## CERTIFICATE OF APPROPRIATENESS

**Property:** 213 Bayland Avenue, lots 23 and 24, block 4, Woodland Heights Subdivision. The property includes a vacant 5,000 square foot (50' x 100') interior lot.

**Proposal:** New Construction – The applicant was approved at the November 7, 2013 HAHC meeting to construct a 3,765 square foot two-story single-family residence with an attached two-story garage. The applicant has revised the approved residence and submitted it for considerations. The revisions include the following:

**SOUTH ELEVATION – FRONT FACING BAYLAND AVENUE**

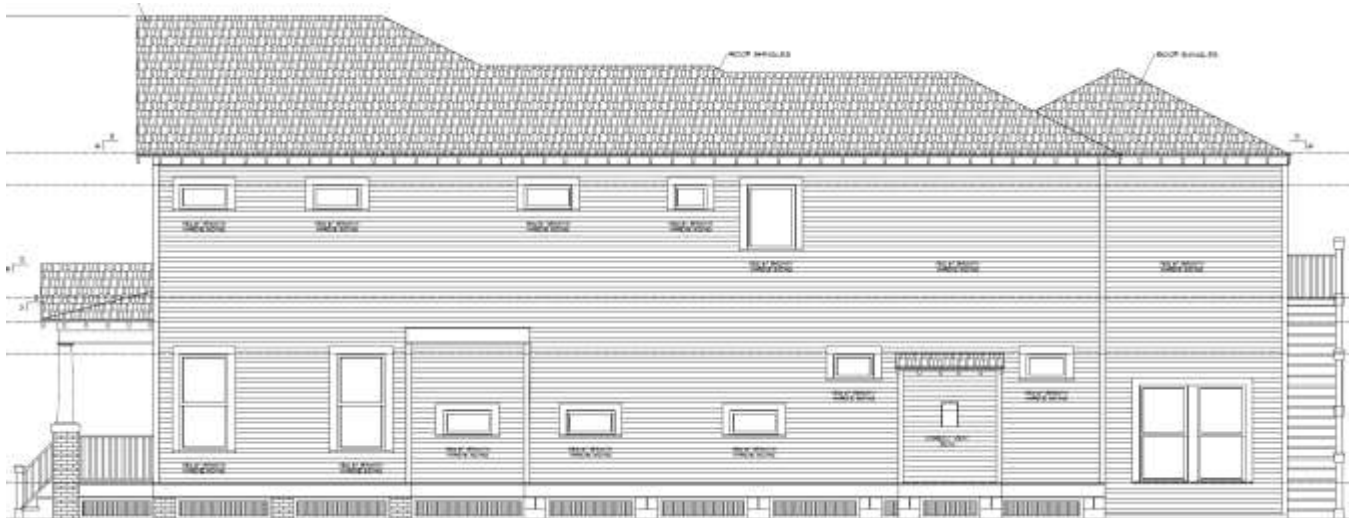
- Change the eastern portion of the front porch to a wood pergola porch cover from the previously approved full width front porch hipped roof.
- Change 1-over-1 sash windows to 2-over-1 sash windows
- Change the siding on front gable from cementitious horizontal lap siding with a 6" reveal to wood shingle shakes.
- Change siding on the south and east elevations of the attached garage from cementitious horizontal lap siding with a 6" reveal to wood shingle shakes.
- Install hipped roof dormers on the north and south elevations of the garage and a hipped roof dormer on the north elevation of the residence.

| <input type="checkbox"/>            | <input checked="" type="checkbox"/> | <input type="checkbox"/>            | (2) The exterior features of new construction must be compatible with the exterior features of existing contributing structures in the historic district<br><i>Wood pergola porch covers are not a typical features of front porches in the historic district</i> |

- Remove the wood pergola and continue the hipped porch roof over the full width front porch.

- Remove the wood pergola and continue the hipped porch roof over the full width front porch.

**NORTH (REAR) ELEVATION**

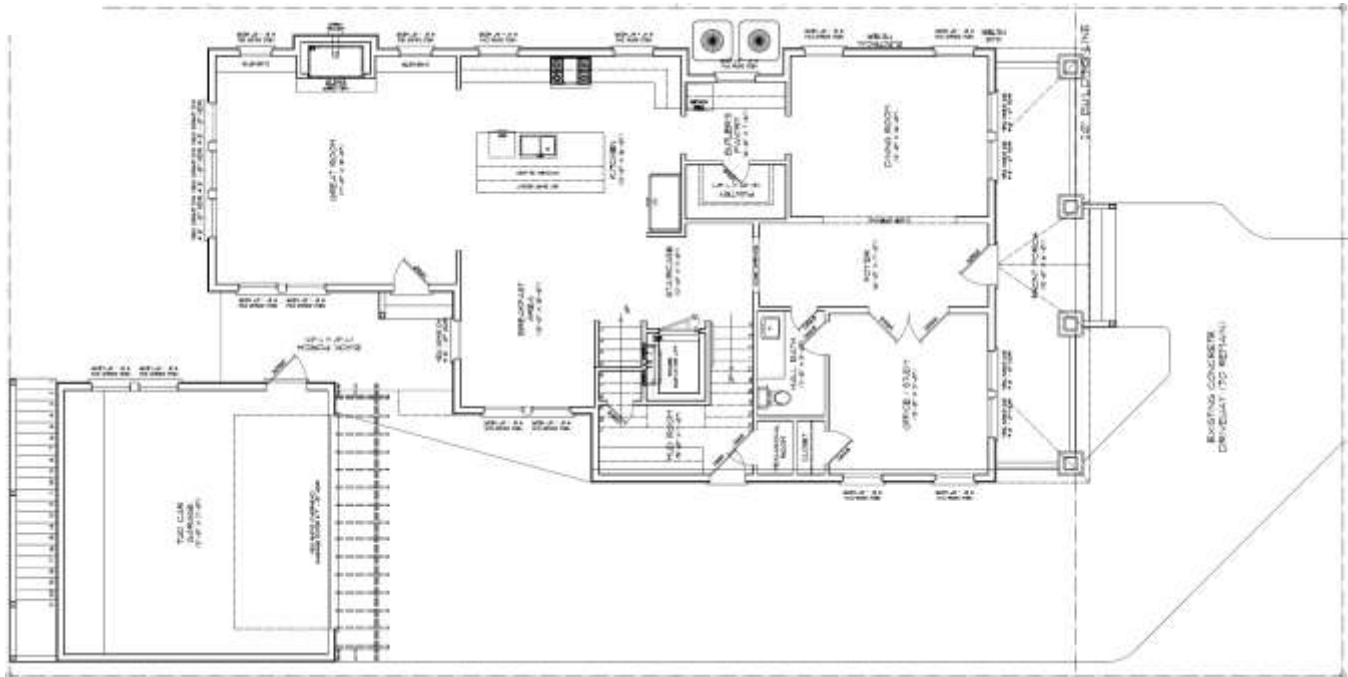
A hipped roof dormer will be added to the north elevation of the residence and hipped dormers will be added to the north and south elevations of the garage. The dormers will feature slatted vents.

## ROOF PLAN

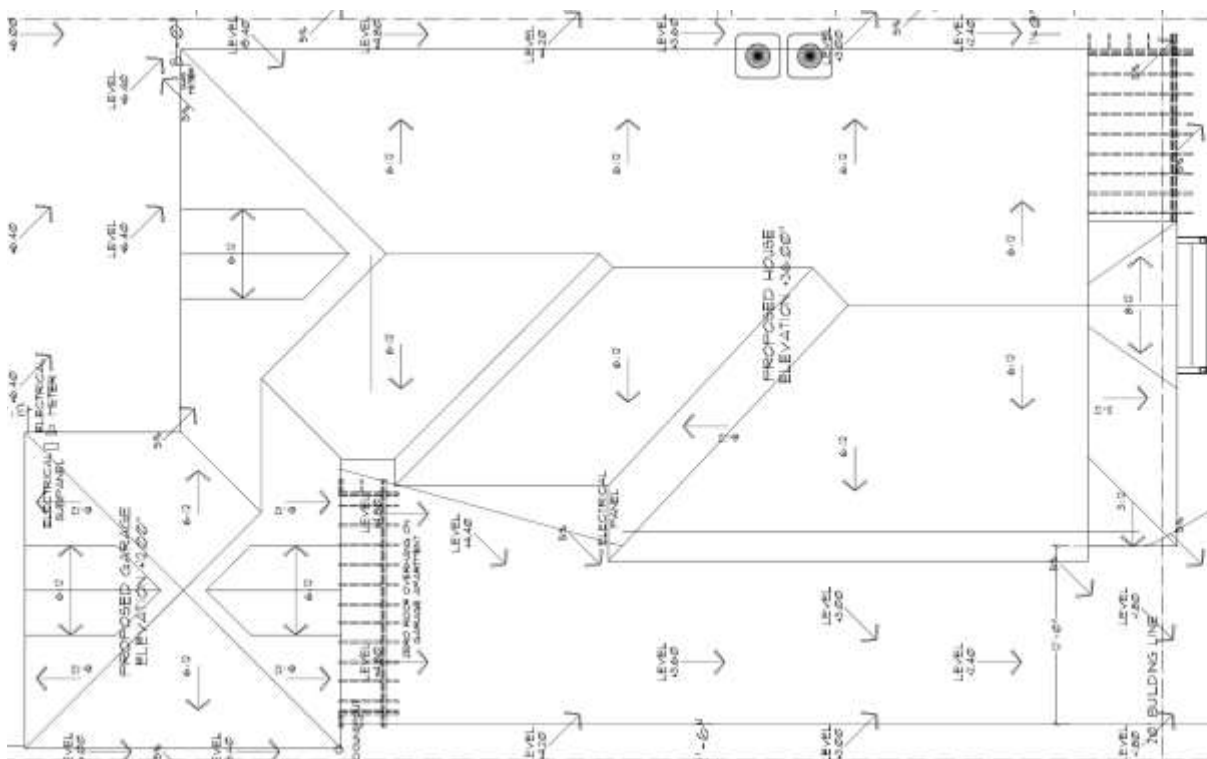
**Roof:** The eastern section of the full width front porch will feature a wood pergola porch covering (previously approved full width front porch with a hipped roof).
